WINSOME FILING NO. 3
EL PASO COUNTY, COLORADO
CONSTRUCTION DOCUMENTS
HORIZONTAL CONTROL

WINSOME FILING NO. 3
EL PASO COUNTY, COLORADO
CONSTRUCTION DOCUMENTS
CULVERT 1-PLAN & PROFILE

Culvert CDs_v1 redlines.pdf Markup Summary

WINSOME FILING NO. 3
EL PASO COUNTY, COLORADO
CONSTRUCTION DOCUMENTS
CULVERT DETAILS

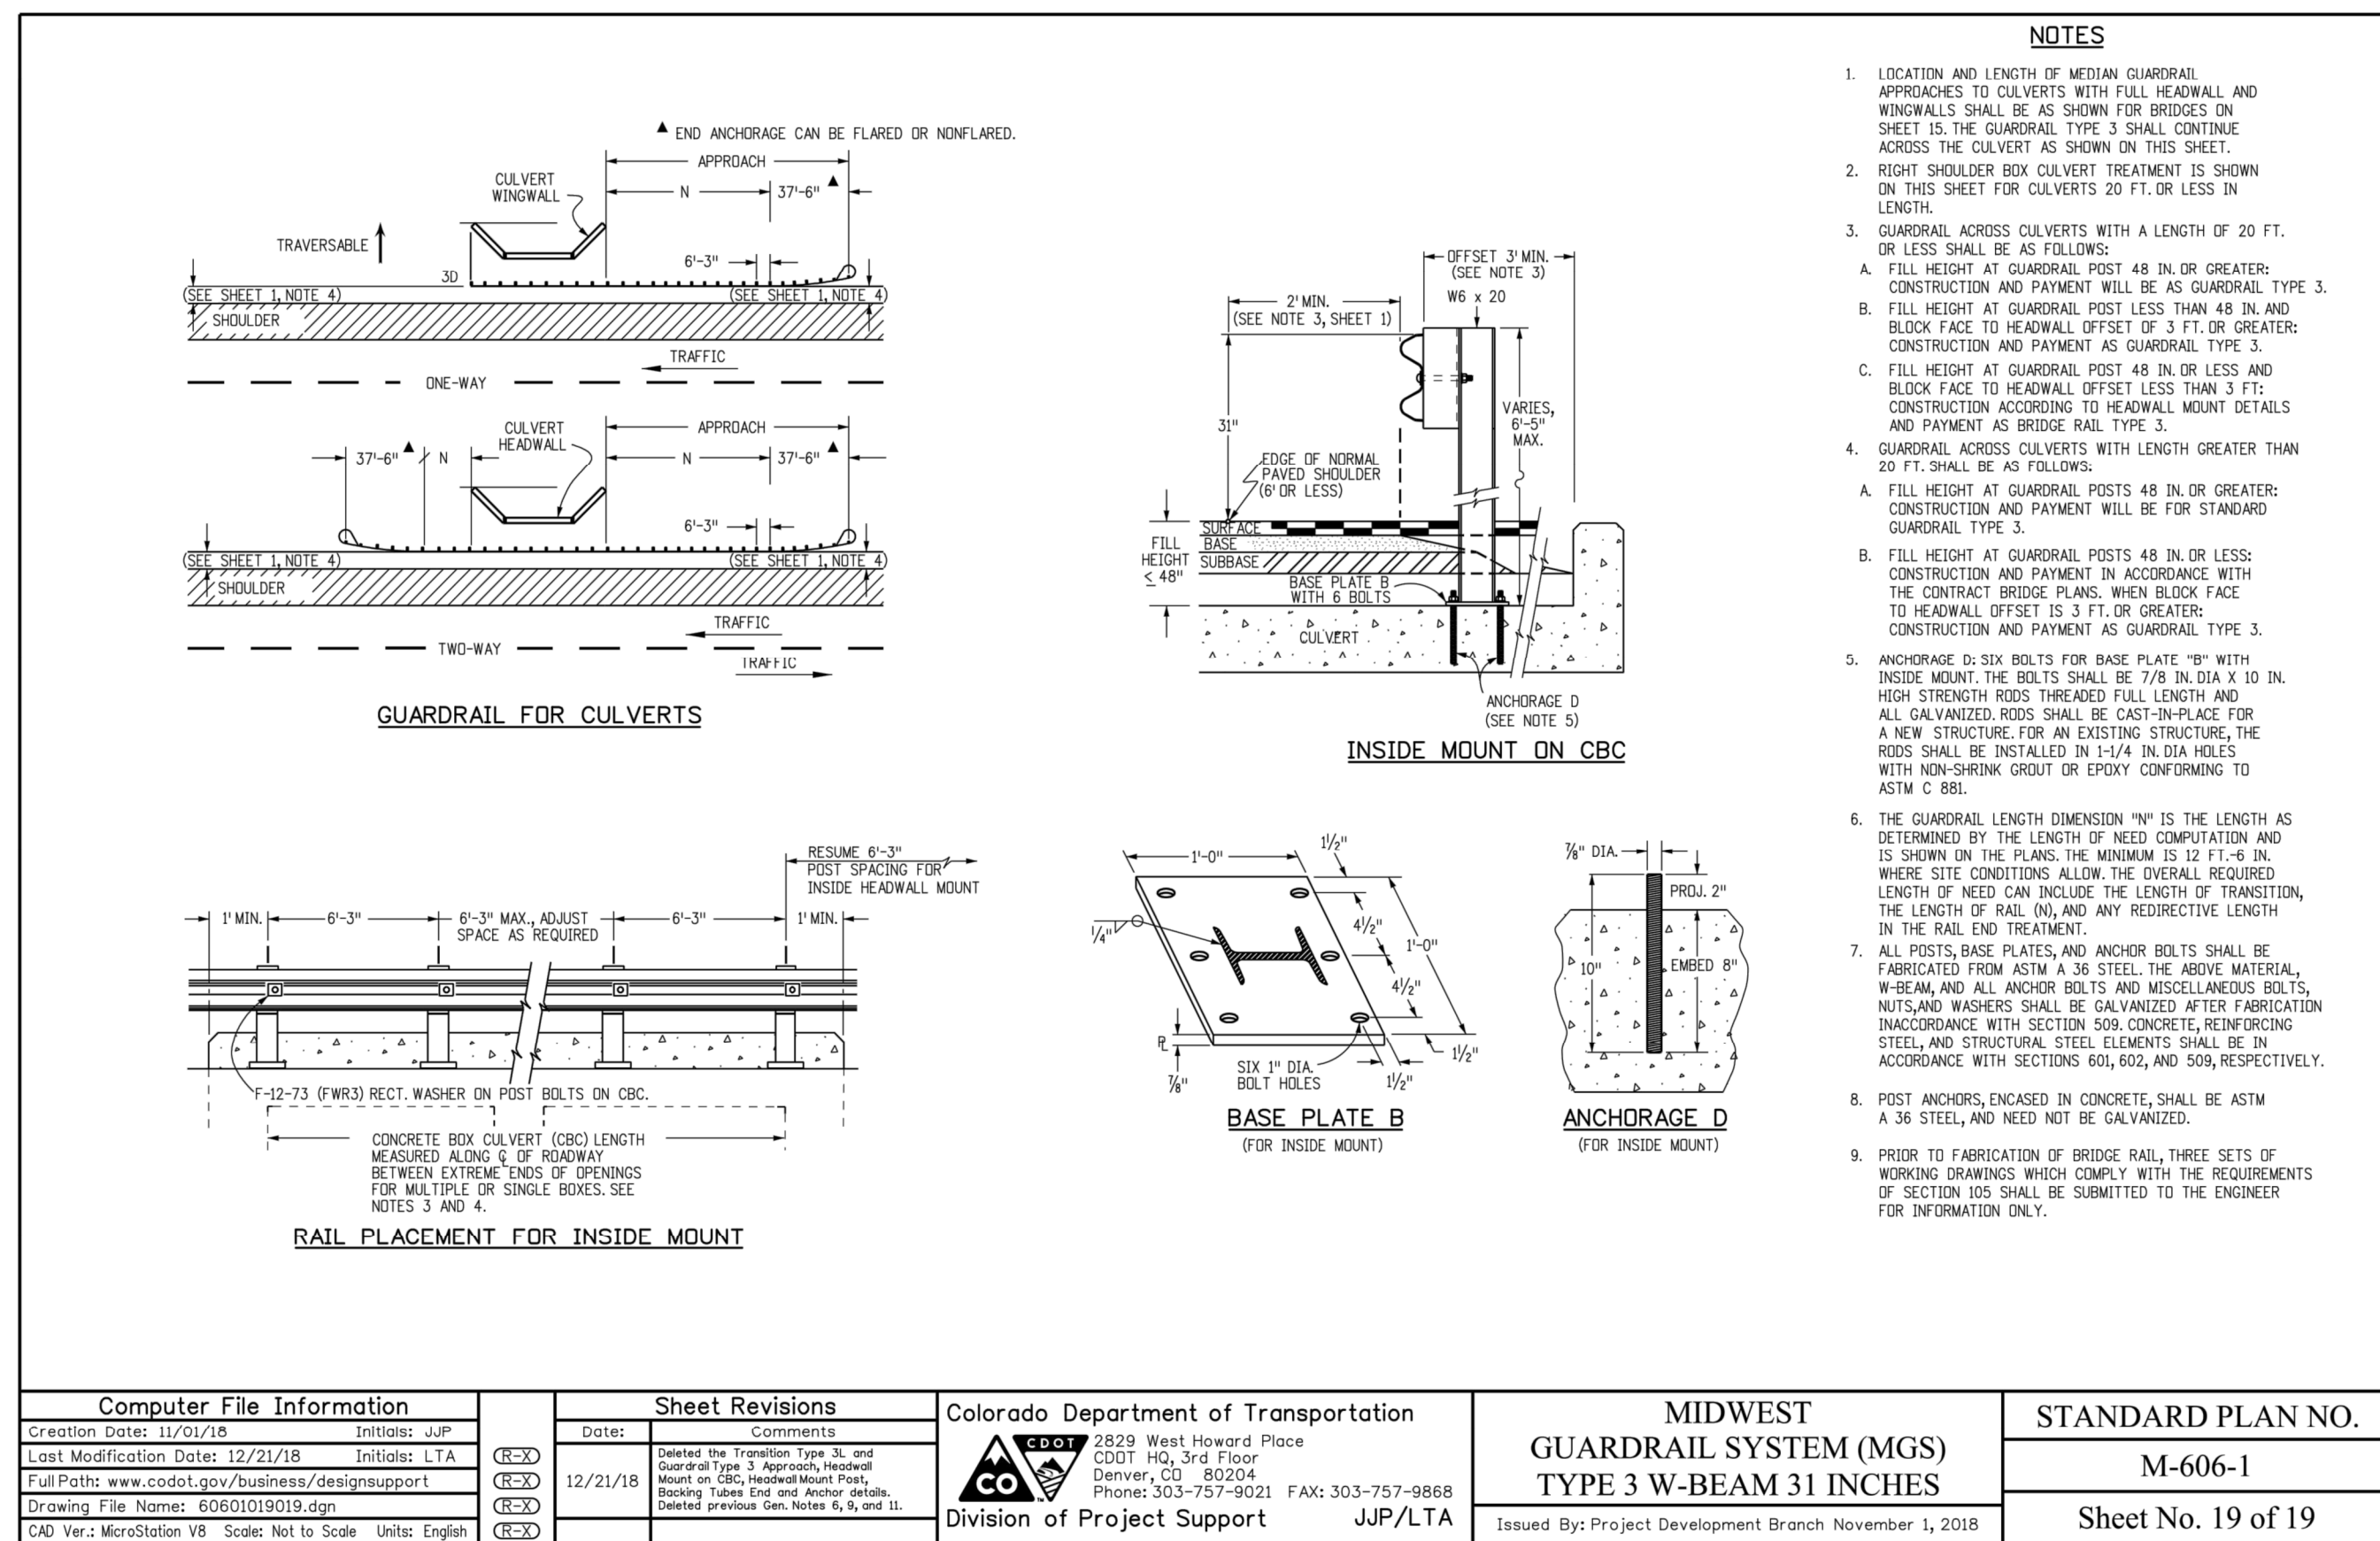
Add all the applicable CDOT Detail M-606-1 sheets

ADDED MORE APPLICABLE GUARDRAIL DETAILS.
